**From:** Noeleen Keavey  
**Sent:** 09 August 2006 14:48  
**To:** Ann Bosley  
**Subject:** FW: RK1721 FW: Youghal - Review of AVR report

**From:** Sinead Hickey [mailto:sinead.hickey@sws.ie]  
**Sent:** 11 July 2006 15:42  
**To:** 'Valerie Hannon'  
**Subject:** RE: RK1721 FW: Youghal - Review of AVR report

**From:** Cieciora, Paul A  
**Sent:** Monday, July 10, 2006 1:06 PM  
**To:** Murray, Kevin J  
**Subject:** Youghal - review of AVR report

AVR – Environmental Solutions Ltd. propose to develop a Waste Recovery/Transfer and Sludge Drying Facility in the townland of Foxhole, Youghal, Co. Cork. The site of the proposed development is located off the R634 (former N25 Cork to Waterford Road) adjacent to the existing Youghal Landfill and Civic Amenity Centre.

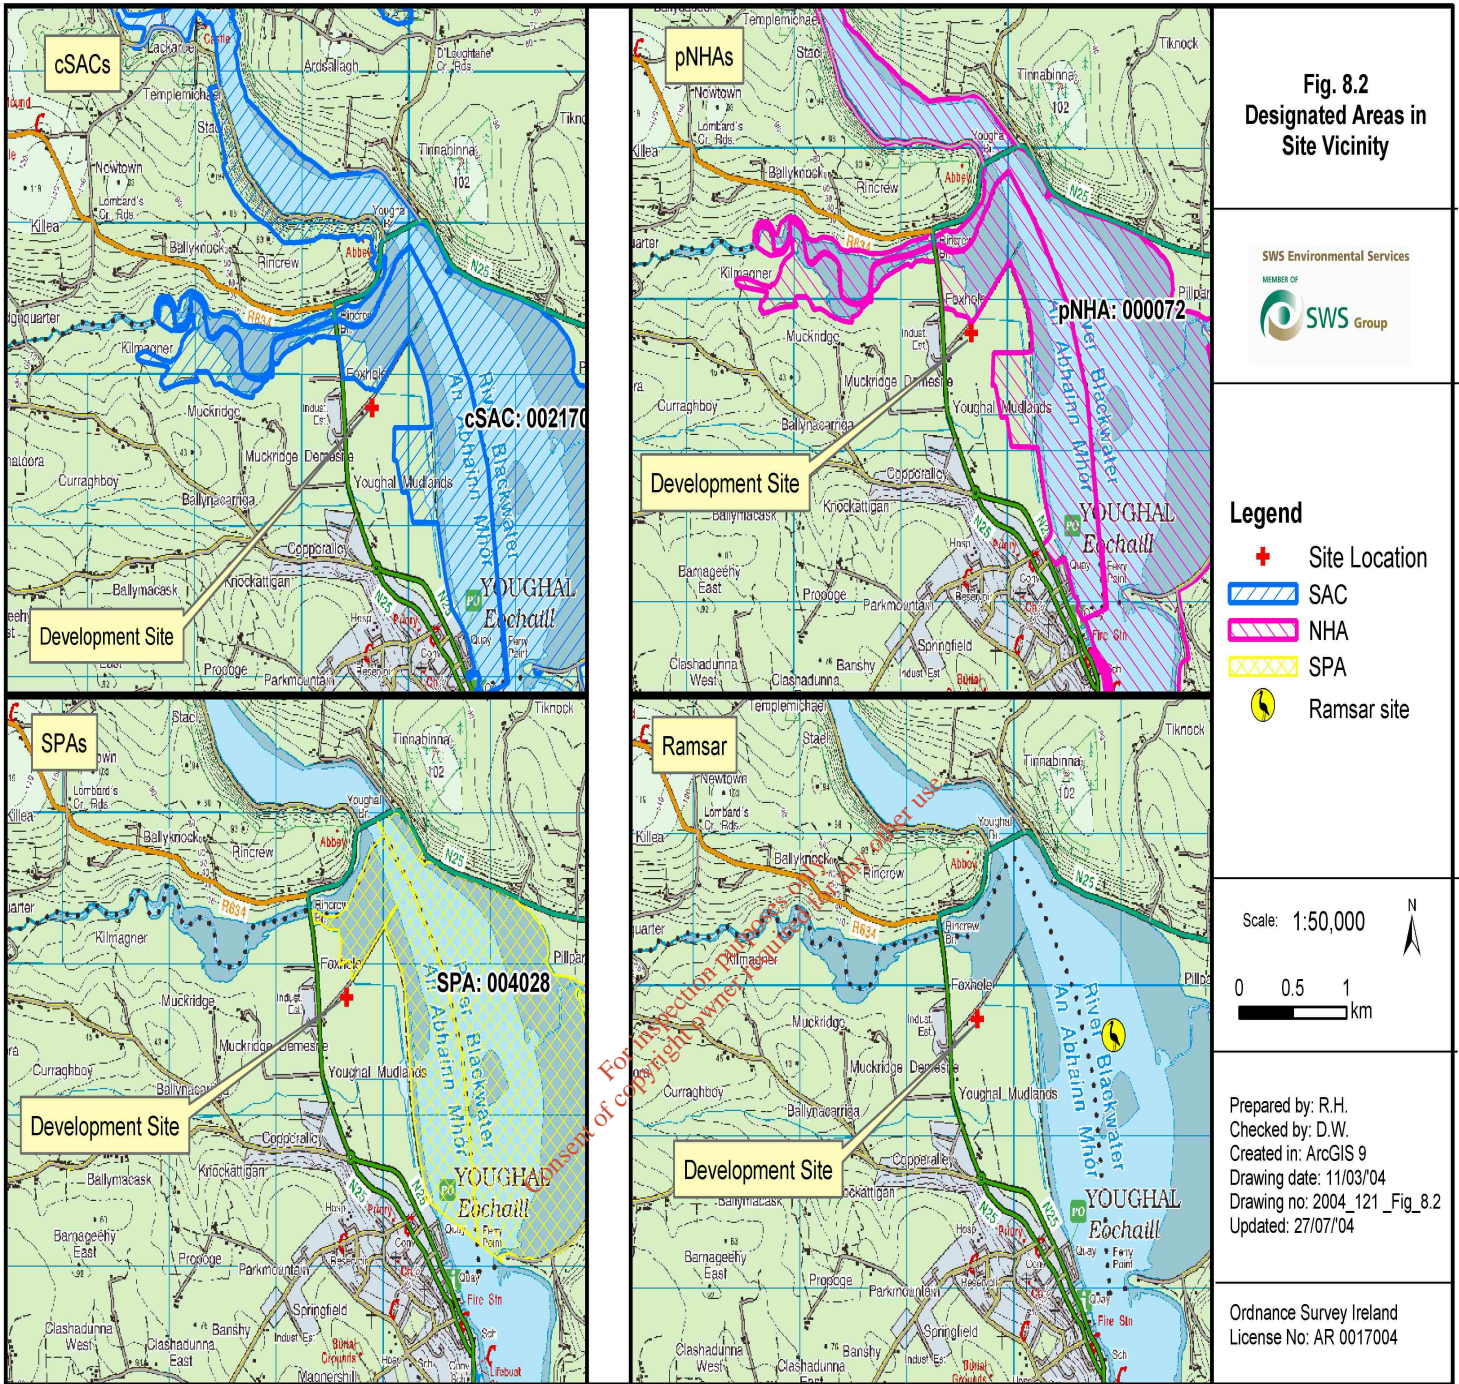
Also attached is a map showing the site relative to designated areas and a summary of the designations. I also got in touch at the time with Shane O' Boyle from EPA and also Liz Slides of NPWS and Chris Embro who were both involved with the Biomar study who confirmed that at the nearest monitoring site that no species of interest were recorded. Chris Embro was also involved in the survey undertaken at the

**Fig. 8.X**  
**Youghal Bay Monitoring**  
**EPA Water Quality**

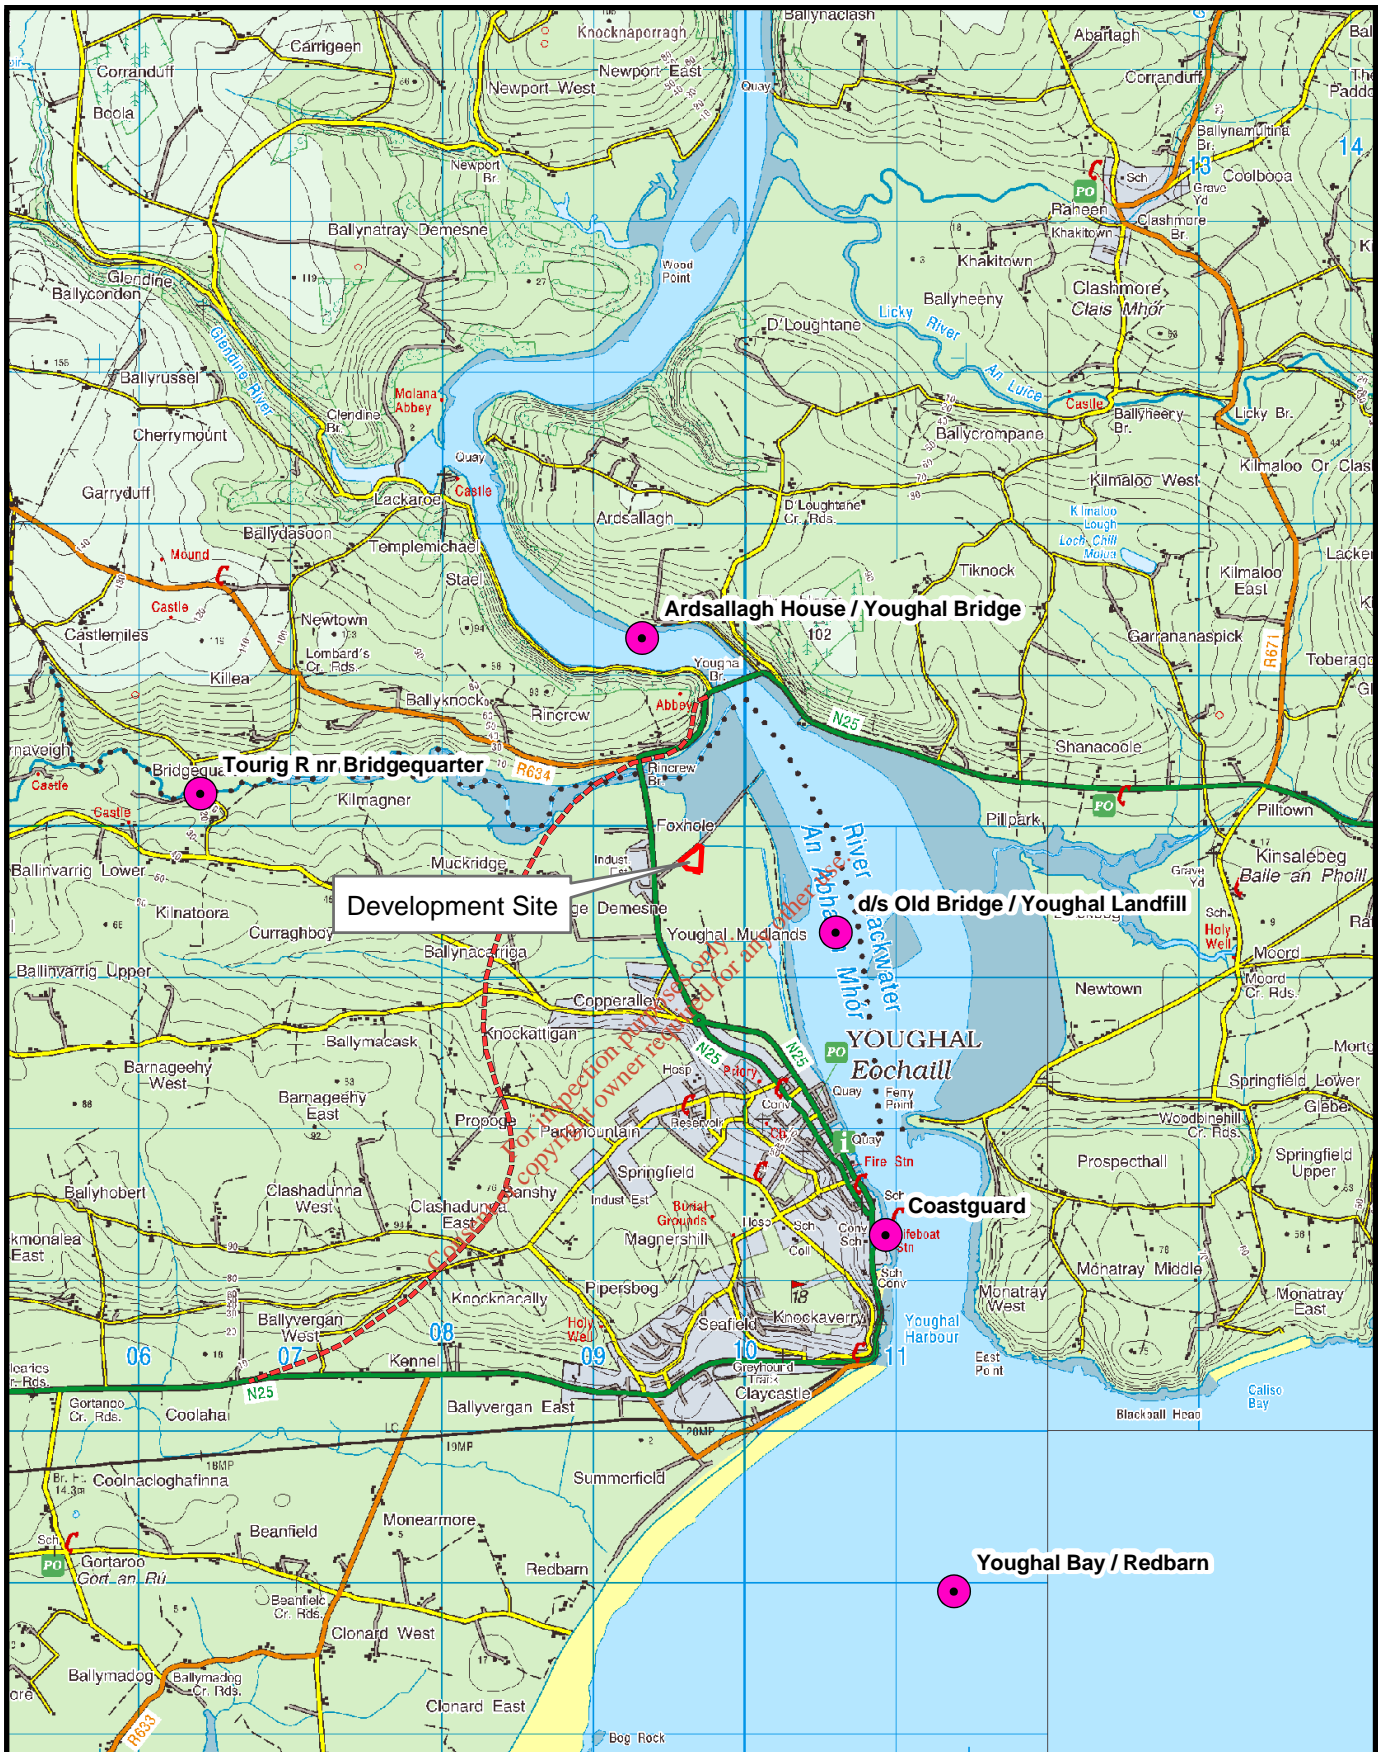
2. Attached is a map which shows the site discharge point to the outfall pipe at Foxhole, Youhal relative to the AVR plant. The discharge point is into the estuary and is out at the end of what remains of the old bridge. You can see the EPA monitoring points U/S and D/S of the discharge point. Youghal Town Council have no objection in principle to allowing the discharge to the outfall pipe at Youghal subject to meeting discharge requirements set by CCC and the EPA (letter attached). Therefore the modeling was undertaken with respect to the chemical and biological parameters to ensure that the discharge and extent of mixing zone is compatible with the receiving water. Because this outfall will be discontinued in the medium term when the Yougal Waste Water Treatment System comes into operation (in about 5 years time from speaking with the Sanitary Division of CCC) the discharge had to meet, at a minimum the requirements of the Urban Water Water Directive and also meet other relevant discharge parameters as outlined in the additional information submitted to the EPA based on discussion with the licencing officer. The condensate has therefore to be treated on site and then in c 5 years the treated discharge will be sent to Yougal Waste Water Treatment System when constructed as the EPA do not really want a number of discharge points into the bay.
